ADA Curb Ramp New Construction Inspection Form (Perpendicular)

Nw 315th Ave

24952.54

Nw Timeric dr

PERPENDICULAR RAMP (PR)

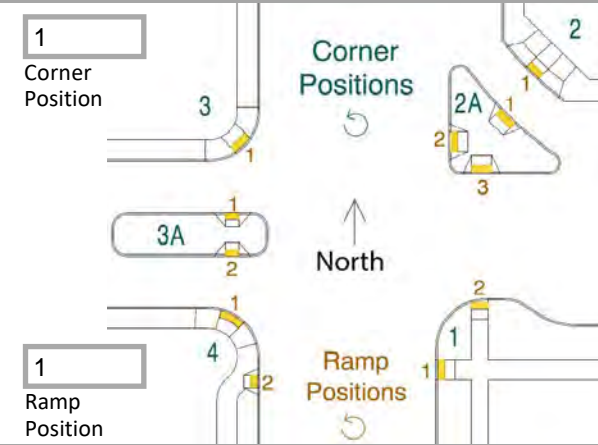
Turn space not center on ramp
